From: Brussel, John
Sent: Monday, August 15, 2005 4:40 PM
To: aabarraz@gw.dec.state.ny.us
Cc: joel.robinson@bayermaterialscience.com; MOLINA, JOSEPH; khmurphy@gw.dec.state.ny.us
Subject: Re: Modification to Demolition Work Plan - Bayer Hicksville
Attachments: Demo WP Modification_081505.pdf; Figure 3_revised 081505.pdf

**ATTACHMENT 1
MODIFICATION TO THE DEMOLITION WORK PLAN**

**BAYER MATERIALSCIENCE LLC
125 NEW SOUTH ROAD
HICKSVILLE, NEW YORK**

FIGURE
3

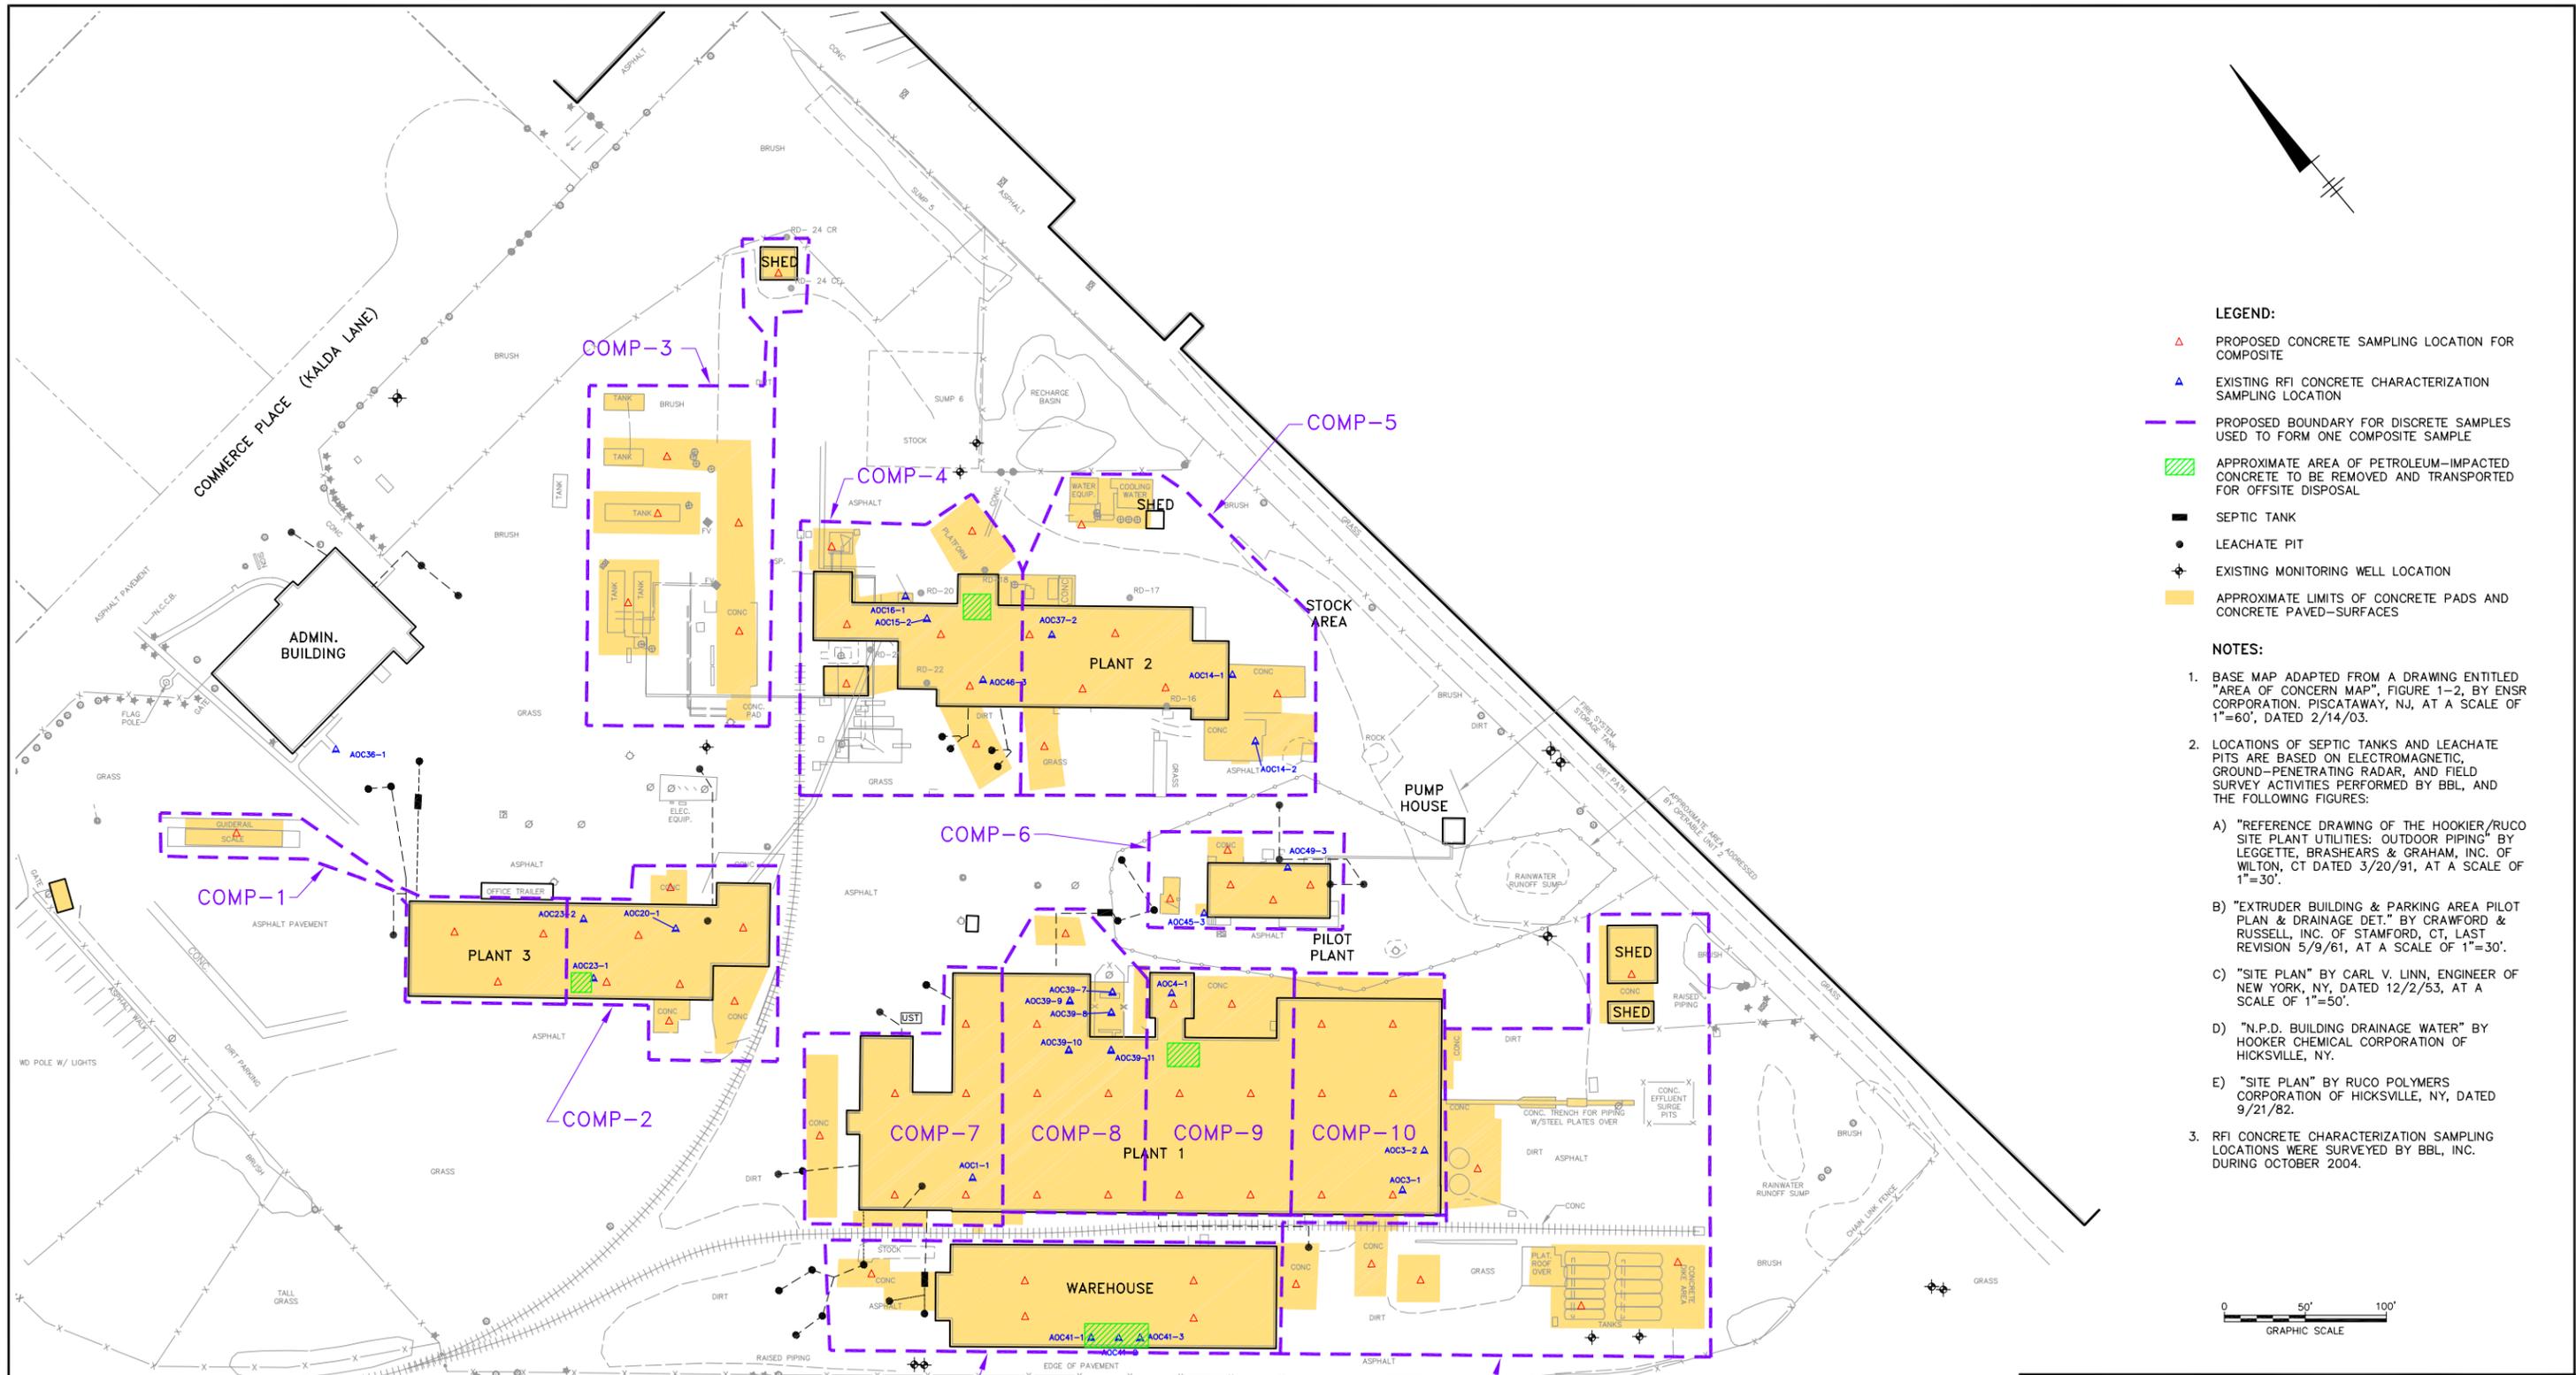
The total number of composite samples and discrete samples is insufficient. The building slab floors should be divided into grids and a minimum of one composite sample taken from each grid. The total number of composite and discrete samples for each grid will vary depending on the size and condition of the concrete, but they should be representative of the area being sampled. Discrete samples should focus on areas where cracks and staining (other than from petroleum spills) were observed from previous concrete sampling, as summarized in the table in section 1.3.4 (Previous Concrete Sampling).

There are also concrete areas outside of the floor slabs where no sampling or insufficient sampling is proposed. These areas should also be divided into grid(s) for composite samples, as described above.

Additional discrete and composite concrete core samples will be collected to further evaluate the presence and extent of PCBs in the former building concrete floor slabs and concrete-paved areas outside the floor slabs. Under the proposed revised sampling approach, a total of 72 representative discrete samples will be collected (instead of 39 as called for in the Demolition Work Plan). The proposed discrete sampling locations will provide additional coverage across the building floor slabs, coverage in concrete-paved areas outside the slabs where no samples were previously proposed, and coverage in the general areas identified in the table in Subsection 1.3.4 where possible staining/slight staining was noticed by field sampling personnel during the RFI. Discrete samples to evaluate concrete re-use will not be collected from areas where heavy staining is observed, because concrete from such areas will be segregated during demolition for proper offsite transportation and disposal.

Under the revised sampling approach, a total of 12 composite samples will be collected, each formed from four to seven discrete samples. The revised composite sample quantity equates to one composite characterization sample per approximately 310 cubic yards (CY) of concrete anticipated to be generated by the demolition activities. Locations where discrete samples will be collected to generate composite samples are shown as red triangles on the revised version of Figure 3 (see attached PDF file). The purple lines on Figure 3 designate boundaries for each composite sample. As indicated by the purple lines, the actual area of concrete to be characterized by each composite sample is approximately the same (just over 100 feet by 100 feet). An analytical sample summary, which identifies the proposed 12 composite samples, sampling areas, and corresponding number of discrete samples to form each composite, is presented below.

As indicated above, areas of concrete flooring exhibiting heavy petroleum staining will be transported for proper offsite disposal. [The approximate areas of concrete flooring exhibiting heavy petroleum staining are shown on Figure 3. Actual limits of stained concrete will be determined based on observations during a reconnaissance in support of the pre-demolition characterization sampling.](#) Bayer had originally planned to collect discrete PCB concrete samples (uncomposited) to evaluate disposal requirements for the heavily-stained concrete. However, upon further consideration and discussion with the NYSDEC during an August 11, 2005 conference call, Bayer may instead elect to first remove the stained concrete and then collect one or more composite samples to characterize the concrete (as-generated) for disposal. Bayer will coordinate with the anticipated disposal facilities to see that the necessary analytical data is provided.

Under the revised sampling approach described in Response 1, sample coverage is now provided in each area outside the concrete floor slabs.
